**STAFF REPORT**  
**(One-Step Final Plat)**

**CASE NUMBER:** S/D 99-73 -- 127<sup>TH</sup> RETAIL ADDITION

**LOCATION:** Southwest corner of 127<sup>th</sup> St. East and Central

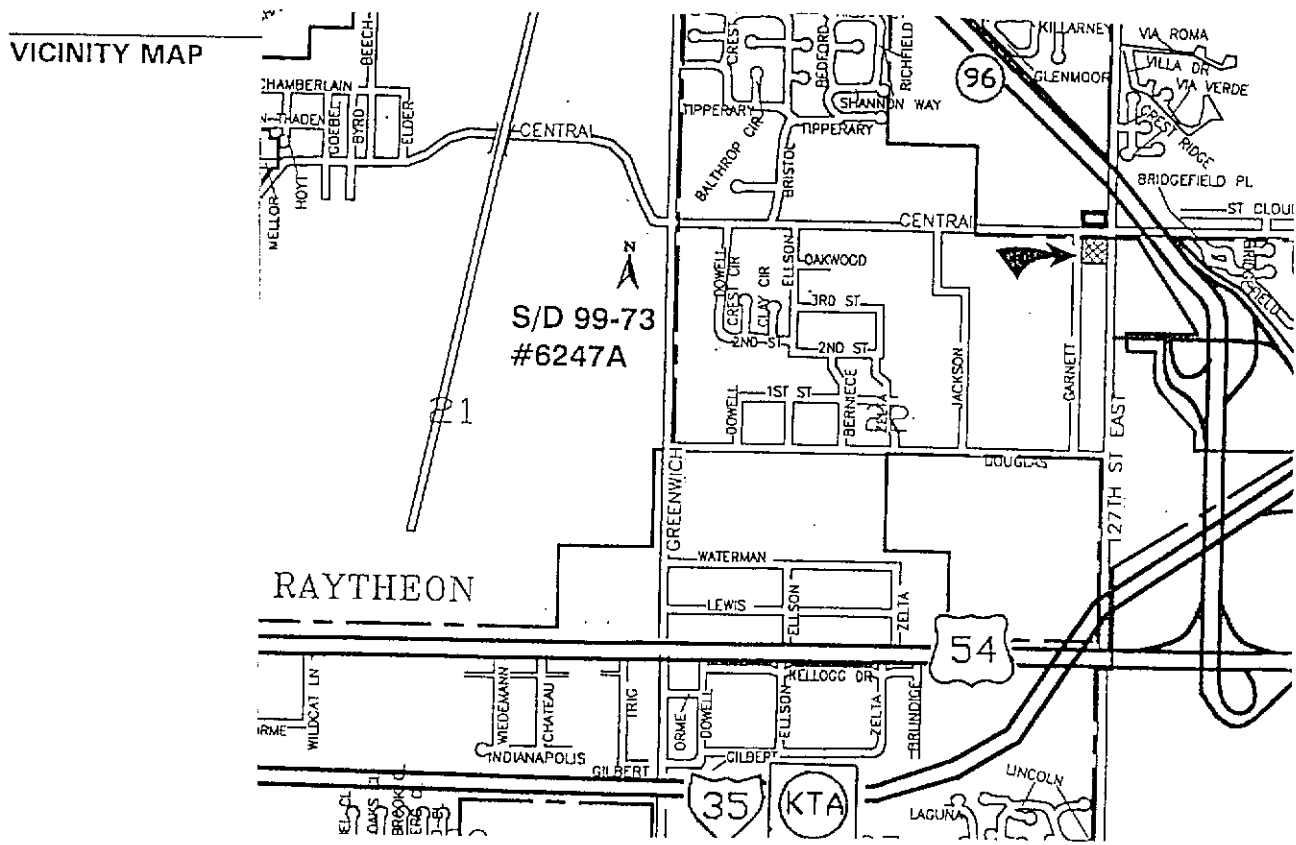
- A. County Engineering needs to comment on the need for any guarantees or easements. The site will be served by the Four Mile Creek sanitary sewer system.

- B. City water appears to be available to serve this site. City Engineering needs to comment on the need for guarantees or easements.
- C. If improvements are guaranteed by petition, a notarized certificate listing the petitions shall be submitted to the Planning department for recording.

- D. City Engineering needs to comment on the status of the applicant's drainage plan.
- E. In accordance with the CUP approval, the plat proposes one joint access opening and one major access opening for both Central and 127<sup>th</sup> St. East. The joint opening on Central is limited to right-in/right-out turn movements by construction of a channelized "Y" opening at the site entrance or by construction of a raised central median on Central. The CUP also permitted one access opening along Garnett located up to 300 feet south of Central, and a second access opening if the property to the west is rezoned from SF-6, Single Family Residential. Distances shall be shown for all segments of access control. The plat's text shall note that the access controls are being dedicated to the City of Wichita and that the location of the openings are subject to approval by the City Engineer.

- F. The Applicant shall guarantee the closure of all driveway openings being located in areas of complete access control or that exceed the number of allowed openings.

- G. The joint access easements shall be established by separate instrument. The instruments shall state the purpose of the easement as well as which properties benefit from the easement. Initial construction responsibilities and future maintenance of the driveways within the easement shall also be addressed by the text of the instrument.

- H. In accordance with the CUP approval, a cross-lot access and circulation agreement shall be provided.
- I. Traffic Engineering needs to comment on the need for improvements to perimeter streets. In accordance with the CUP, the following traffic improvements are required: a continuous right turn lane along 127<sup>th</sup> St. East, extension of the left turn lane on Central at least 30 feet west of the curb of the major opening, and a guarantee for paving of Garnett if proposed to be used for access.

- J. The Applicant is reminded that a landscape buffer is required along the southern property line.

- L. On the final plat tracing, a note shall be placed on the face of the plat indicating that this Addition is subject to the conditions of DP-247.
- M. The platator's text shall include language that a drainage plan has been developed for the plat and that all drainage easements, rights-of-way, or reserves shall remain at established grades or as modified with the approval of the applicable City or County Engineer, and unobstructed to allow for the conveyance of stormwater.
